Detailed Site Plan

The HUB at College Park

DSP-19054

STAFF REPORT

Figure 1: South Elevation

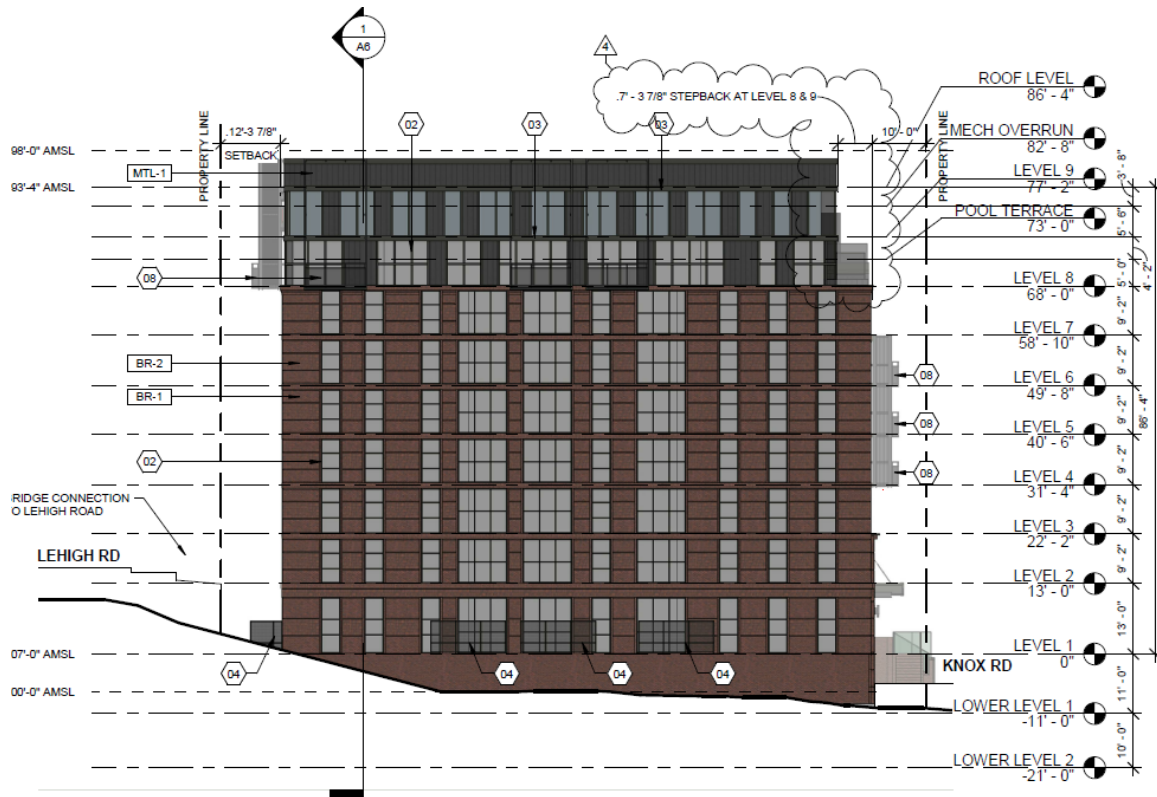
- q. Correct the landscape schedule and Schedule 4.1 to reflect the landscape plan.
 - r. Consider replacing the metal panels at the 7th story (top floor) of the eastern side of the Knox Road façade with brick to provide a consistent 7 stories of brick on all façades of the building, and provide a prominent cornice treatment around the entire building at the 7th story, as requested by the City of College Park.

Figure 7: Wall sign located on the northwest corner of the ninth story

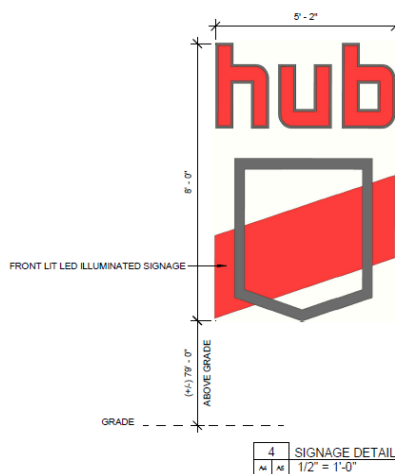
- h. Provide a sign table listing the number of signs, size, material, lighting, and their location on the façades, in accordance with the applicable Development District Overlay Zone standards.

Figure 9: Building sections showing the height compared to surrounding buildings. Top: West elevation Bottom: South elevation

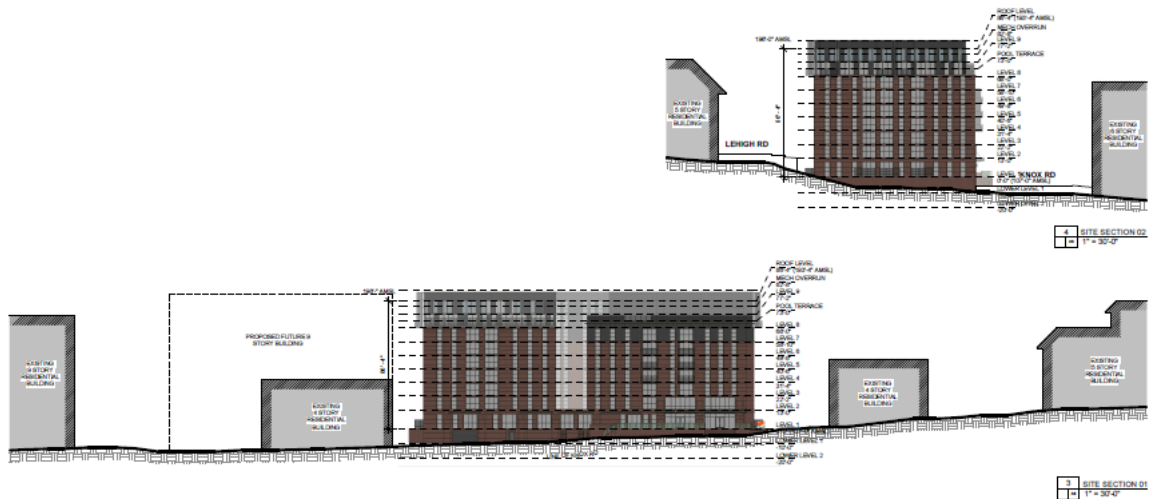
- a. **Page 234–Building Form/Character Area 5A/Walkable Nodes/Building Height:** To increase the height by three stories from the maximum six stories permitted in the Walkable Node to nine stories.

The proposed 9-story building height would conform to the Walkable Node (University) height provisions, but a 3-story amendment is required in the Walkable Node. The applicant’s justification is that the plan and County policies promote density at this location because of the proximity to the University of Maryland campus. In addition, the topography of the site changes 20 feet from one end to the
